# Access Compliance Report

## Public Rights-of-Way

### (Curb Ramps)

Intersection ID: 27070	Main Street: ANDREWS_LINKS_ST	Cross Street: LINKS_DR	Location: SE
ADA ID: 199A6846E574	Ramp Type: PerpDiag	Initial Pass/Fail: Fail	Overall Compliance: No
Codes/Mitigation Info/Possible Solution		Field Measurements/Component Compliance	
Severity Score: 33.75

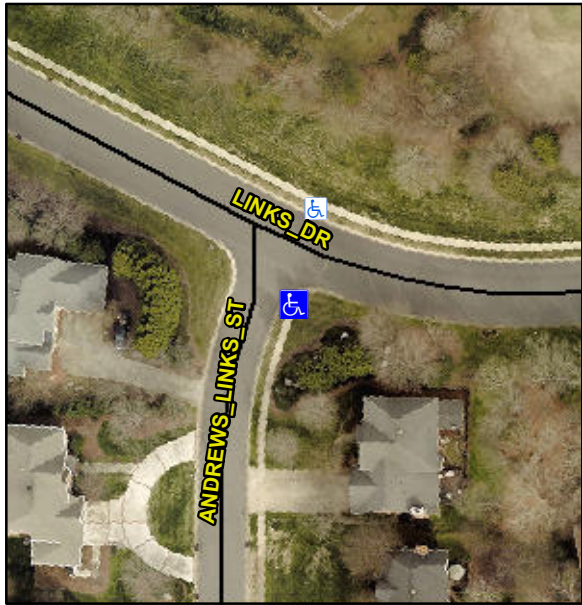
R304.5.1, R304.5.3

Compliance	Description	Data	Compliance	Description	Data
N/A	Ramp Length (in)	95.0	Yes	Ramp Slope (%)	7.9
No	Ramp Width (in)	47.5	No	Ramp XSlope (%)	14.3
N/A	Flare Type LT	N/A	N/A	Flare Type RT	N/A
N/A	Flare Slope LT (%)	N/A	N/A	Flare Slope RT (%)	N/A
N/A	Flare Traversable LT?	N/A	N/A	Flare Traversable RT?	N/A
N/A	Landing Length (in)	N/A	N/A	DWS Provided?	N/A
N/A	Landing Width (in)	N/A	N/A	DWS Contrast?	N/A
N/A	Landing Slope (%)	N/A	N/A	DWS Length (in)	N/A
N/A	Landing X Slope (%)	N/A	N/A	DWS Full Width?	N/A
N/A	Landing Curb? (Y/N)	N/A	N/A	DWS Offset (in)	N/A
N/A	Shared Landing?	N/A			
N/A	Gutter Ponding?	N/A	N/A	Gutter Slope (%)	N/A
N/A	Gutter Lip Ht (in)	N/A	N/A	Gutter X Slope (%)	N/A
N/A	Painted X Walk1?	No	N/A	Painted X Walk2?	No
	X Walk 1 Direction	To NE		X Walk 2 Direction	To NW
N/A	X Walk 1 Width (in)	N/A	N/A	X Walk 2 Width (in)	N/A
	X Walk 1 Slope (%)	2.3		X Walk 2 Slope (%)	8.3
	X Walk 1 X Slope (%)	11.4		X Walk 2 X Slope (%)	6.4

Remove & Replace Curb Ramp With Two New Directional Ramps or Equivalent.
